ENVIRONMENTAL REVIEW TEAM REPORT  
ON THE  
MILL HILL INDUSTRIAL PARK  
COLCHESTER, CONNECTICUT  
FEBRUARY, 1975

EASTERN CONNECTICUT RESOURCE CONSERVATION  
AND DEVELOPMENT PROJECT  
Environmental Review Team  
139 Boswell Avenue  
Norwich, Connecticut 06360

### MILL HILL INDUSTRIAL PARK COLCHESTER, CONNECTICUT

# TOPOGRAPHY AND DRAINAGE

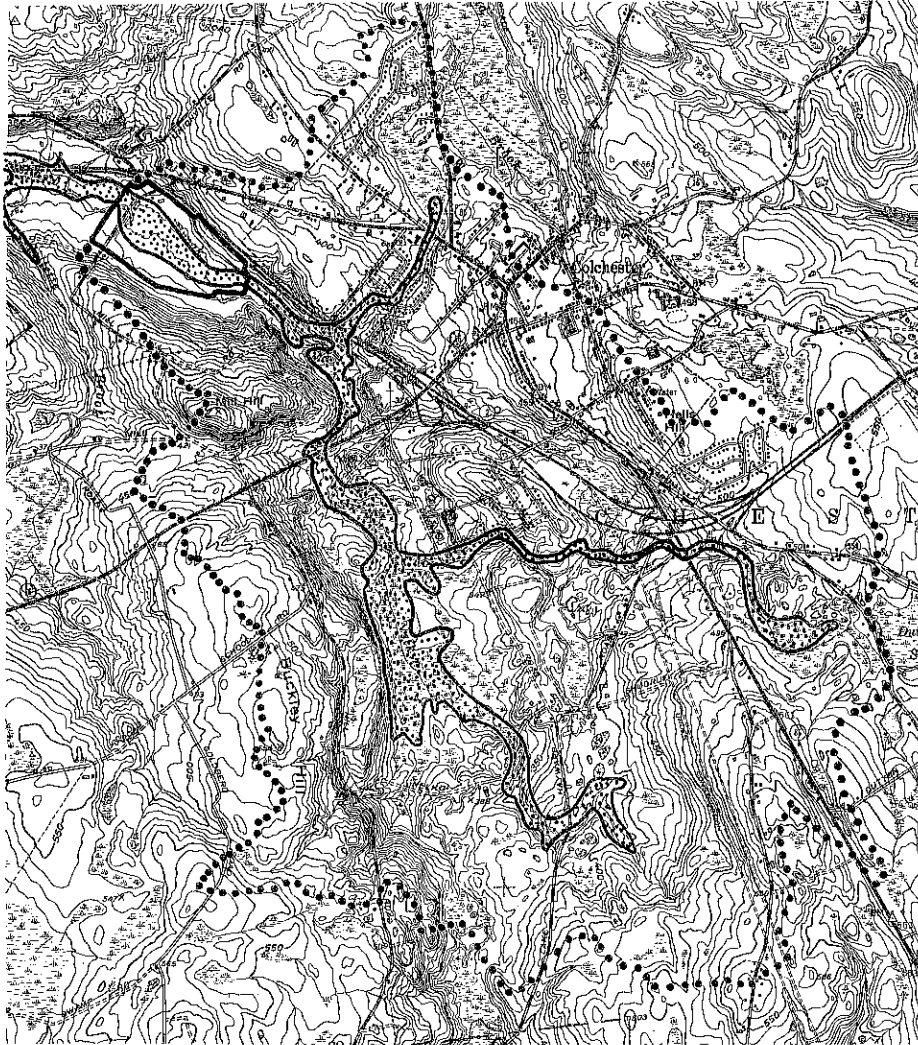
The total land area drained by Meadow Brook is 11.3 square miles. From the point where Meadow Brook passes under Mill Hill Road the immediate drainage area is approximately 6.8 square miles (see Topography and Drainage map on the opposite page). All the surface water runoff within this area eventually exists at the Mill Hill Road bridge. Under topographic conditions, excluding any alterations to the natural drainage patterns by existing road networks, the areas presently prone to flooding for the 1 in 100 year flood are as outlined on the map (taken from the USGS Floodprone Areas Map).

As shown on the Topography and Drainage map on page 7, the drainage area of Meadow Brook at Mill Hill Road is approximately 6.8 square miles. Development of Colchester is presently fairly low within this drainage basin and consequently its affect on Meadow Brook is negligible. However, as Colchester grows and greater percentages of this basin are taken out of the natural condition, significant changes in stream flow patterns and water quality will result.

Flooding. The existing floodprone areas for the 1 in 100 year storm are shown on the Topography and Drainage map. The elevations of floodwaters on the site are controlled by the bridge on Mill Hill Road. Construction of a new bridge could reduce the flood stages in the proposed industrial area. However, this would also tend to increase peak flows downstream of the site, the effects of which should be determined prior to any such construction.

## SURFICIAL GEOLOGY

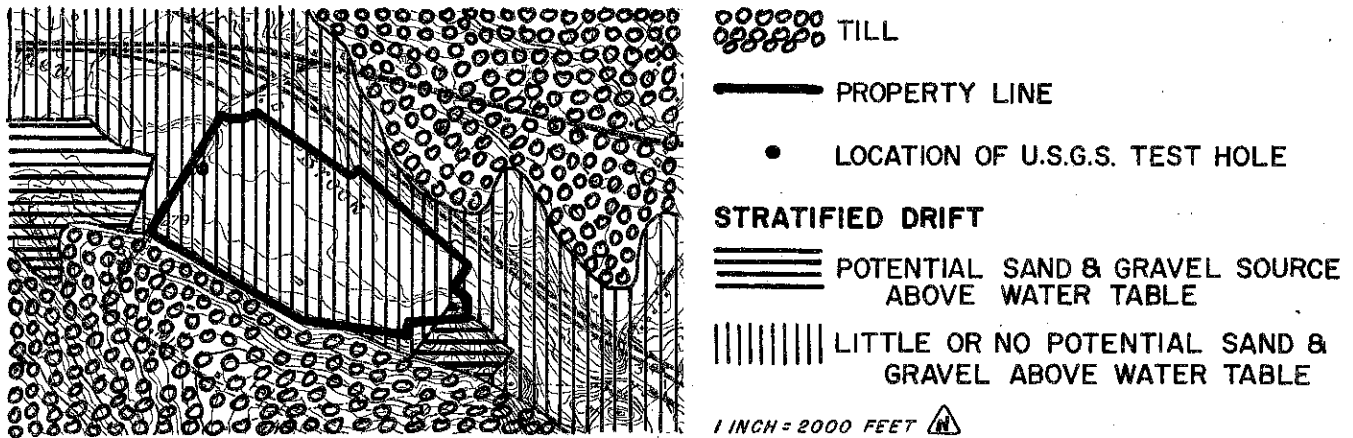
The U.S. Geological Survey drilled a test hole on Mill Hill Road just south of the bridge crossing Meadow Brook. The driller's log is given below. (The location of the test hole and the extent of the stratified drift deposits are shown on the Surficial Geology map on page 9.)

The Surficial Geology map also shows till on the southern boundary of the site. Till is the material carried on or within the glacier that remained where the glacier stopped. It is a fairly compact heterogeneous mixture of varying quantities of boulders, gravel, silt, and clay, with little or no sorting or stratification of the constituents by grain size.

# SOIL MAP

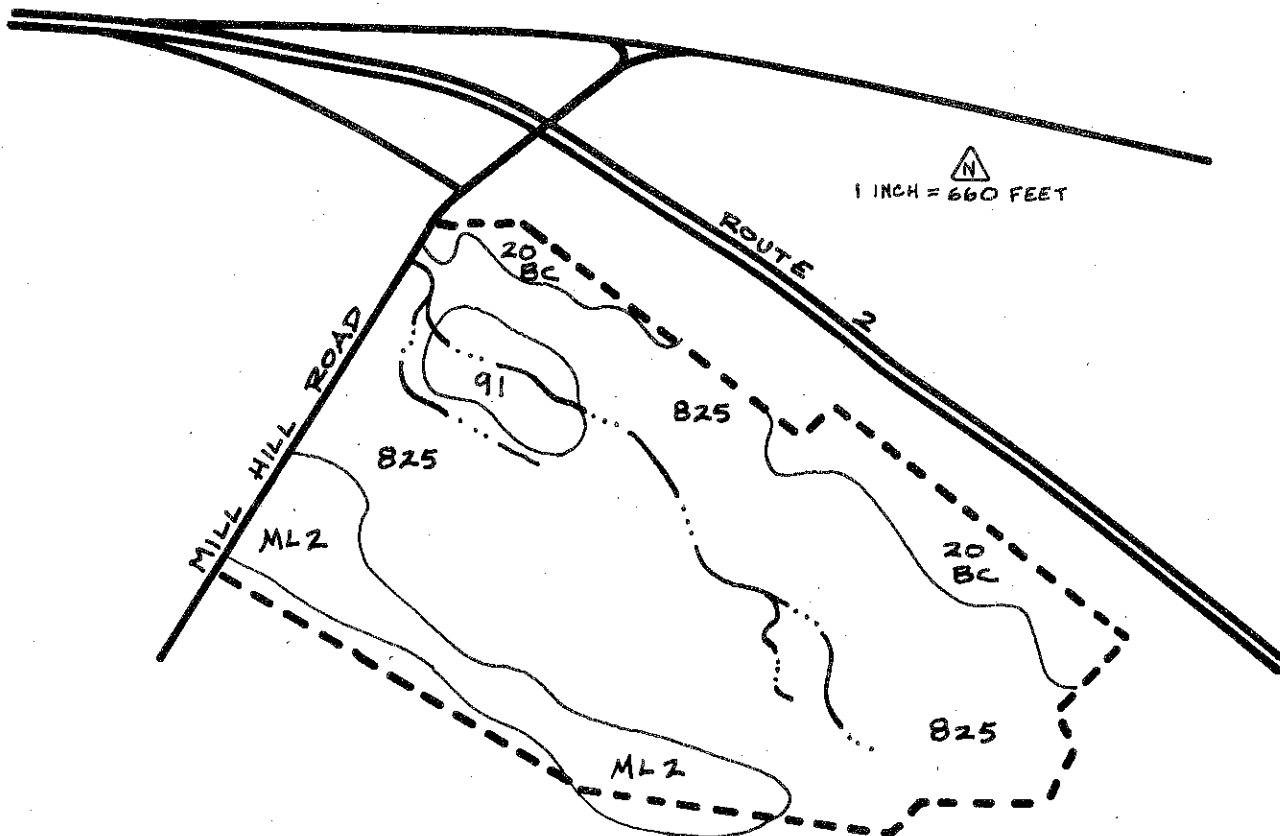
Soils. A detailed soils map of the site is given in the Appendix to this report along with a soils limitations chart. Due to the original scale at which the soils are mapped (1"=1,320') the lines shown on the soils map should not be viewed as precise boundaries, but rather as guidelines to the distribution of soil types on the property. The soils limitations chart indicates the probable limitations for each of the soils for on-site sewage disposal, basements, landscaping, and streets and parking. However, limitations even though severe, do not always preclude the use of the land for development. If economics permit greater expenditures for land development and the intended use is consistent with the objectives of local and regional development, many soils and sites with difficult problems can be used.

As can be seen on the soils map, the majority (76.7%) of the site is composed of inland wetland soils. These include soils 91 and 825. Both of these soils are characterized by high water tables. Use of this area will require a permit from the local inland wetlands agency.

The area mapped as ML2 has been scraped very close to the water table. The Schuster truck terminal is located on the portion closest to Mill Hill Road. A narrow strip along Mill Hill Road has also been filled (car body repair shop), but would still classify as wetlands.

On the northeastern side of the property, there are approximately 9 acres of undisturbed, excessively drained soils (20BC). This is the only portion of the site that can be considered readily suitable for development. However, its location minimizes its potential.
